UNITED STATES PATENT AND TRADEMARK OFFICE

APPLICATION NO.	FILING DATE	FIRST NAMED INVENTOR	ATTORNEY DOCKET NO.	CONFIRMATION NO.
10/737,119	12/17/2003	Hiroshi Kuroda	XA-10006	5995

Office Action Summary	Application No. 10/737,119	Applicant(s) KURODA ET AL.	
	Examiner DiLinh Nguyen	Art Unit 2814

2. Claims 1-3 and 6-12 are rejected under 35 U.S.C. 103(a) as being unpatentable over Hiroaki et al. (JP. 2001-291821) (previously applied) in view of Kanemoto et al. (U.S. Pat. 6410987).

【図1】

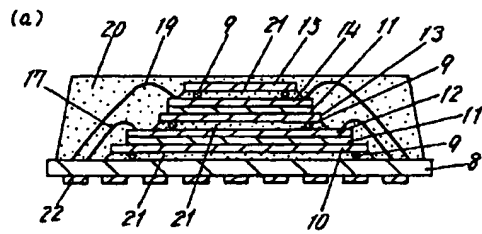
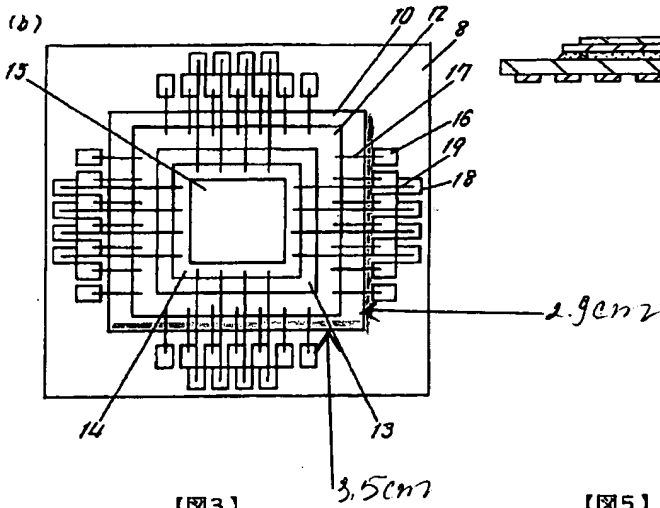
- Regarding claims 1 and 6, Hiroaki et al. disclose a semiconductor device comprising:

- a wiring substrate 8;

- an upper chip 14; and

- a lower chip 10 or 12, the upper chip and the lower chip being mounted over an upper surface of the wiring substrate, and

- wherein the upper chip is constructed as a multiport device including an interface between the upper chip and another part of the system including the lower chip and an interference between the upper chip and outside of the system,

- wherein the lower chip is constructed to be accessed from the outside of the system via the upper chip,

- wherein the upper chip 14 has a substantially square planar shape,

wherein the lower chip 10 or 12 has a substantially rectangular planar shape, with a long side having a greater length than a side thereof adjacent to the long side,

wherein a length of a side of the upper chip 14 is shorter than a length of a long side of the lower chip, and

wherein the upper chip 14 is mounted over the wiring substrate 8 in as state being stacked over the lower chip 10 or 12 (fig. 1, abstract).

- Regarding claim 2, Hiroaki et al. discloses that the upper chip 14 is connected to first electrodes of said wiring substrate 8 via a plurality of bonding wires 19, the lower chip 10 or 12 is connected to second electrodes of said wiring substrate 8 via a plurality of bonding wires 17, said first electrodes are arranged toward an outer periphery side of said wiring substrate from the second electrodes (fig. 1).

- Regarding claim 3, Kanemoto et al. disclose that the memory chip includes a flash memory (fig. 5, column 9, lines 36-37).
- Regarding claim 7, Hiroaki et al. disclose that the upper chip 14 is connected to first electrode of the wiring substrate 8 via a plurality of bonding wires 19, a lower chip 10 of the two chips is connected to second electrodes of the wiring substrate 8 via a plurality of bumps electrodes 9, the chip 12 is connected to third electrodes of the wiring substrate 8 via a plurality of bonding wires 17, the first electrodes are arranged toward an outer periphery of the wiring substrate from the second and third electrodes (fig. 1, abstract).

- Regarding claim 9, Hiroaki et al. disclose a lower surface of the wiring substrate 8 is formed with a plurality of bump electrodes 22 constructing external connection terminals (fig. 1).

- Regarding claim 10, Hiroaki et al. disclose the upper chip 14 and the lower chips 10 or 12 have respective terminals, and it would have been obvious to form a number of terminals of the upper chip being much greater than a number of terminals of the lower chips (fig. 1). Moreover, the number of terminals would have been obvious to an ordinary artisan practicing the invention because, absent evidence of disclosure of criticality for the number of terminals giving unexpected results, it is not inventive to

- Regarding claim 11, Hiroaki et al. disclose the terminals of the lower chips 10 or 12 are arranged such that they are not superposed over the terminals of the upper chip 14 in plan view (fig. 1).
- Regarding claim 12, Hiroaki et al. disclose that an under fill resin 21 is filled in a gap between the lower chip 10 and the wiring substrate 8 (fig. 1).
